# PARK PLACE AT WESTCHESTER AIRPORT

# **Final Supplemental Environmental Impact Statement**

December 2016

This Final Supplemental Environmental Impact Statement (FSEIS) responds to comments made at the Public Hearing for the Draft Supplemental Environmental Impact Statement (DSEIS) on April 4, 2016, and responds to written comments received by the Planning Board, as Lead Agency. This FSEIS also describes modifications to the proposed project made in response to comments, and presents the supplemental analyses of potentially adverse impacts to proposed project modifications. This FSEIS has been prepared in accordance with 6 NYCRR Part 617: Preparation and content of environmental impact statements of the Environmental Conservation Law of New York State.

Existing Conditions Figure 1

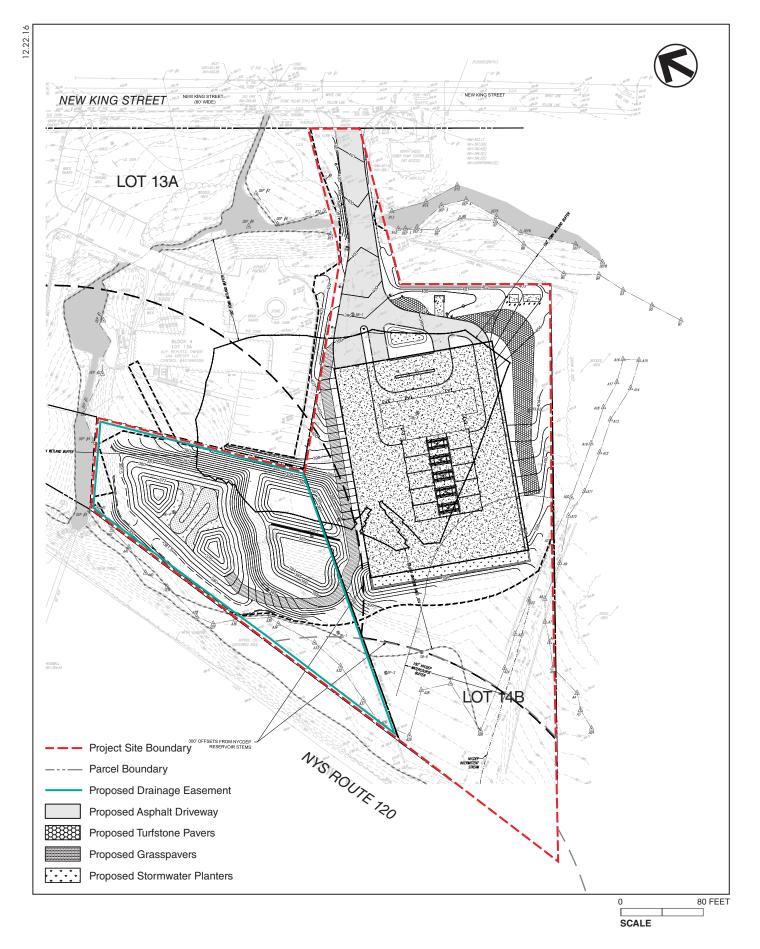
- **Comment 17:** The DEIS does not show the limiting distance from the second Reservoir Stem affecting the site. DEIS Figures 8-1 and 8-2 show two streams that exit the site and immediately enter the Kensico Reservoir. Section 18-16(a)(95) of the Watershed Regulations define a Reservoir Stem as "any watercourse segment which is tributary to a reservoir and lies within 500 feet or less of the reservoir." The DEIS has erroneously omitted information demonstrating the location of the 300-foot buffer from the second Reservoir Stem in relation to the project site. This omission is likely due to the prohibition against the construction of impervious surfaces within 300 feet of a reservoir stem, as set forth in section 18-39(a)(1) of the Watershed Regulations. (Lippes\_Sierra\_1)

- **Response:** The 300-foot offset from the two 500-foot reservoir stems are shown in Figure 1 of the FSEIS. No new impervious surface is proposed in either 300-foot offset to the reservoir stems.
